May 16, 2022

This letter is intended to serve as a comment response letter for the Amara Annexation, Master Plan, and Zoning Second Review of the above requested application dated January 25, 2022, and Revised March 28, 2022. This letter is to accommodate the requested resubmitted plans and documents associated with the application.

RE: Amara (Annexation, Mater Plan and Zoning) - Second Review Comments
File: CPC A 21-00197 - CPC A 21-00207, CPC MP 21-00208, CPC ZC 21-00209

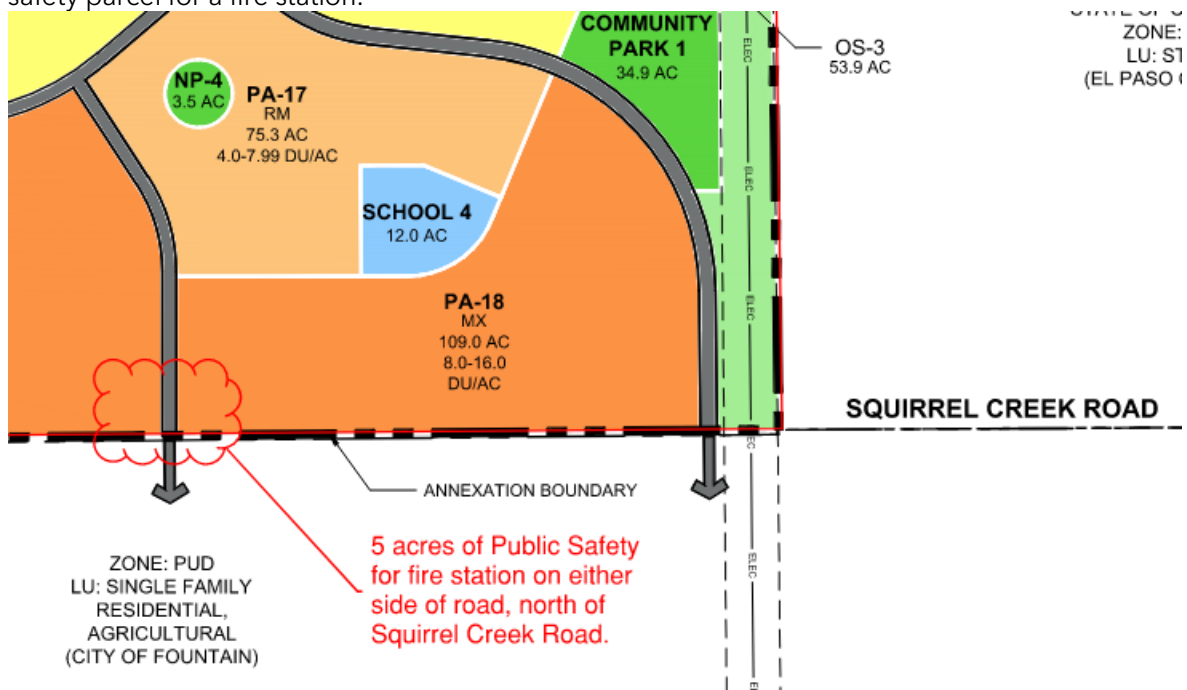
- For General Note 3: please add "pending approval by the FMIC Board" to the end of the note.
- Not Addressed

Response: The note as stated above has been added to the Master Plan.

Response: The note as stated above was modified per the original comment. The note number changed as a note above it in the sequence was removed. This is now Note 2.

**Location of
Proposed
Park Areas**

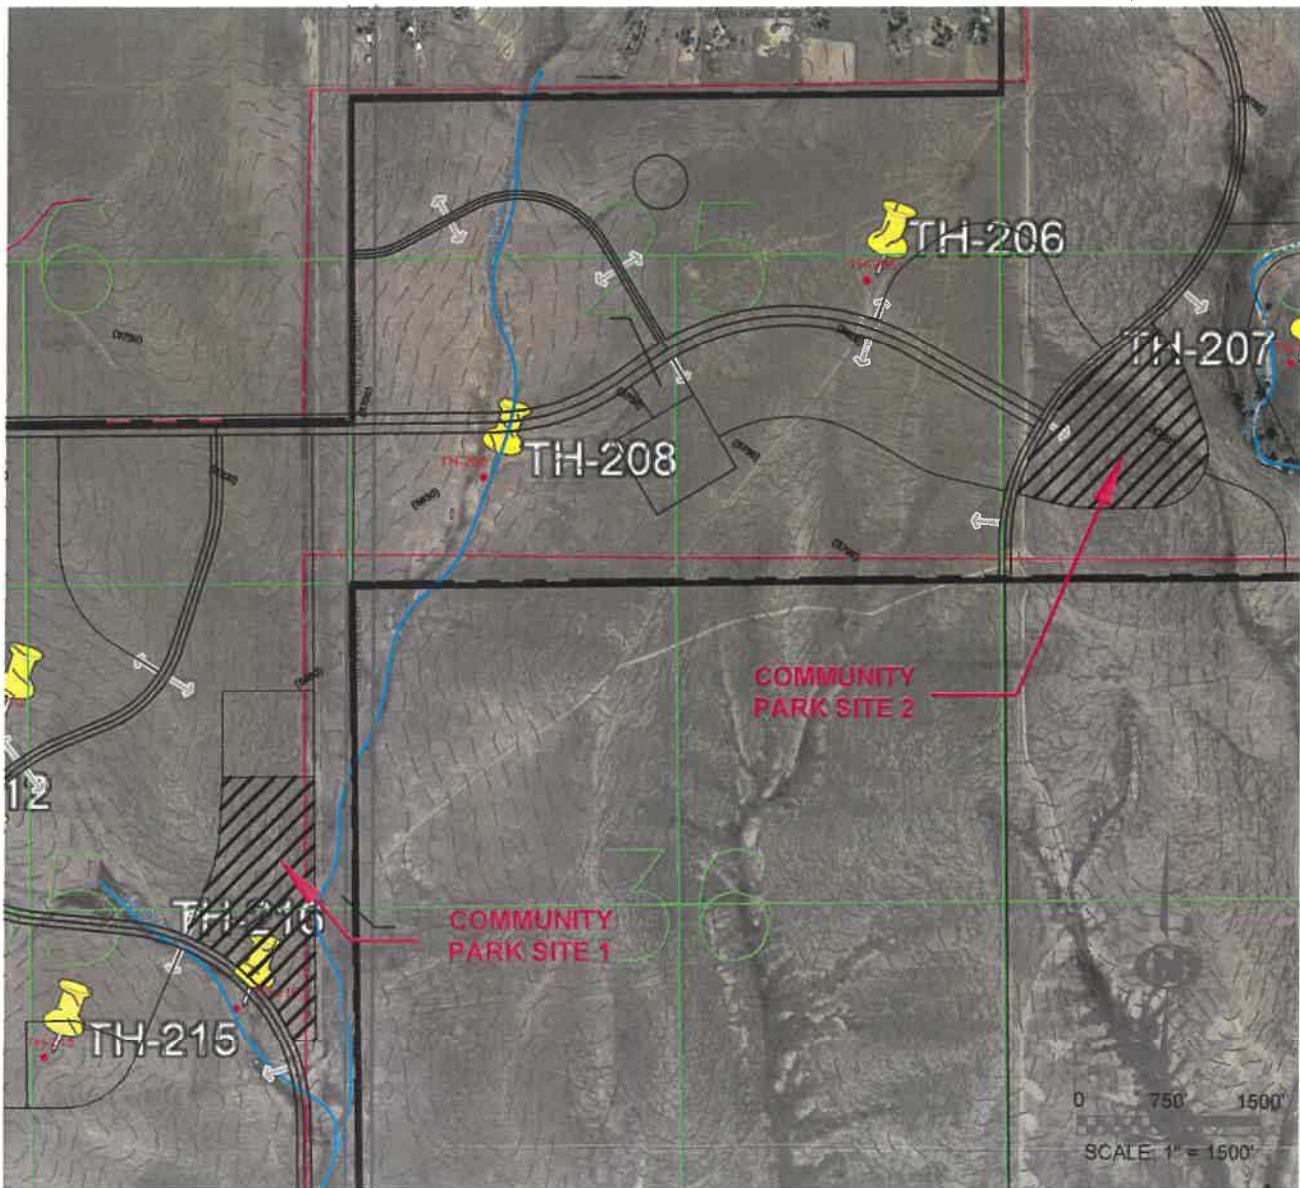
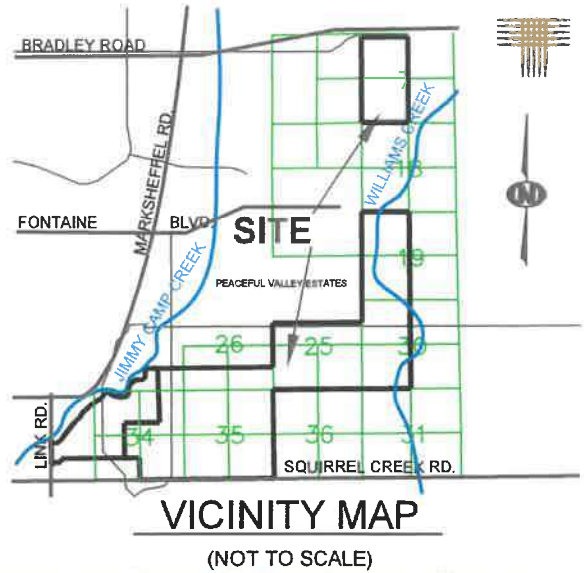
2. Please respond with any findings for a geologic hazard associated with the area where a neighborhood or community park site is shown on the Master Plan.

Response: We respectfully refer you to review the geologic hazards reports prepared by CTL|T under CTL|T Project No. CS19053-115, dated April 1, 2019, December 9, 2021, and associated letters prepared by CTL|T dated November 18, 2020 and March 5, 2021 which we identified and discuss

geologic hazards throughout the site. We believe geologic hazards that pertain to the park areas identified on the master plan by DTJ Design, dated December 10, 2021, will include steep slopes, expansive soils and bedrock, flooding, and erosion potential. The steep slopes adjacent to the existing drainages appear to be unstable and potentially unstable. Slopes outside of the exiting drainages appear to be stable.
